Access Compliance Report

Public Rights-of-Way (Curb Ramps)

Intersection ID: 45731	Main Street: REDWOOD VALLEY LN	Cross Street: PROVENCE LN	Location: SW
ADA ID: 5F1E2B83CACD	Ramp Type: PerpDiag	Initial Pass/Fail: Fail	Overall Compliance: No
			Severity Score: 33.75

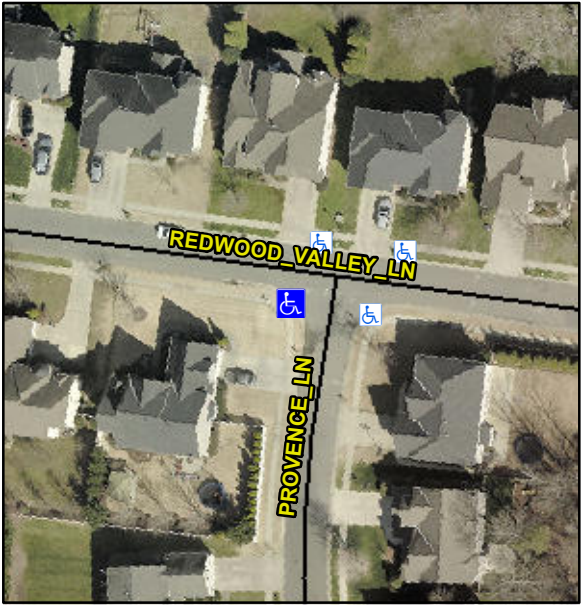
Codes/Mitigation Info/Possible Solution			Field Measurements/Component Compliance		
 Street 1 Name PROVENCE LN Stop Condition-Street 2 StopSign Street 2 Name REDWOOD VALLEY LN Stop Condition-Street 1 None	Possible Solutions:		Compliance	Description	Data
	Remove & Replace Curb Ramp With Two New Directional Ramps or Equivalent.		N/A	Ramp Length (in)	49.0
			No	Ramp Width (in)	43.0
			N/A	Flare Type LT	N/A
			N/A	Flare Slope LT (%)	N/A
			N/A	Flare Traversable LT?	N/A
			N/A	Landing Length (in)	N/A
			N/A	Landing Width (in)	N/A
			N/A	Landing Slope (%)	N/A
			N/A	Landing X Slope (%)	N/A
			N/A	Landing Curb? (Y/N)	N/A
			N/A	Shared Landing?	N/A
			N/A	Gutter Ponding?	N/A
			N/A	Gutter Lip Ht (in)	N/A
			N/A	Painted X Walk1?	No
				X Walk 1 Direction	To SE
			N/A	X Walk 1 Width (in)	N/A
				X Walk 1 Slope (%)	2.6
				X Walk 1 X Slope (%)	2.5
			N/A	Ramp inside XWalk1?	N/A
Surveyor Notes: N/A PROW/ADA: Not Found, R304.5.1, R304.2.2, R304.5.3			N/A	Flare Type RT	N/A
